UNITED STATES PATENT AND TRADEMARK OFFICE

APPLICATION NO.	FILING DATE	FIRST NAMED INVENTOR	ATTORNEY DOCKET NO.	CONFIRMATION NO.
10/017,924	12/07/2001	Hsin-Hong Huang	10541/775	1505
29074 75	590 10/16/2003		EXAMINER	
BRINKS HOFER GILSON & LIONE			GARCIA, ERNESTO	
P.O. BOX 10395 CHICAGO, IL 60611			ART UNIT	PAPER NUMBER
			3679	
		DATE MAILED: 10/16/2003

DETAILED ACTION

Attachment: one marked-up copy of corrected sheet 1 of drawings.

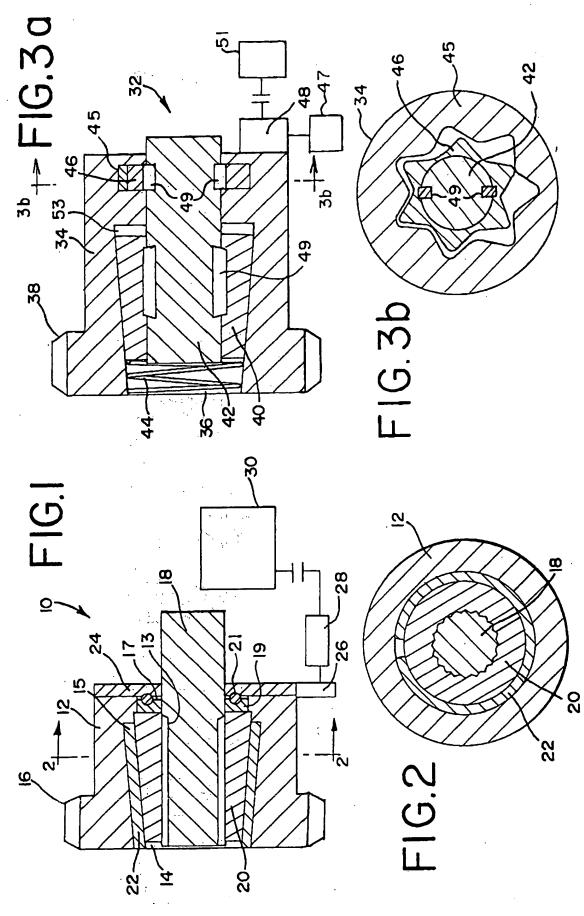
The drawings were received on 7/7/03. These drawings are not acceptable for the reasons below.

The drawings are objected to because the first sheet of the two sheets submitted as corrected sheets contain different figures unrelated to the invention originally submitted to the Office (see attachment). Reference character 30 in Figure 5 should be deleted since 30 does not point directly to a polygonal surface as shown in Figure 2, and the polygonal surface of Figure 2 and Figure 5 are distinct parts and not the same part. Furthermore, the axis 25 is still not aligned from the left side to the right side of 24. Applicant is urged to use a straight edge to confirm this discrepancy. The lead line of reference 40 appears to point to the driven member 24 in Fig. 4. Reference character 24 in Figure 4 should be arrowed as it appears to point to the gear 26.
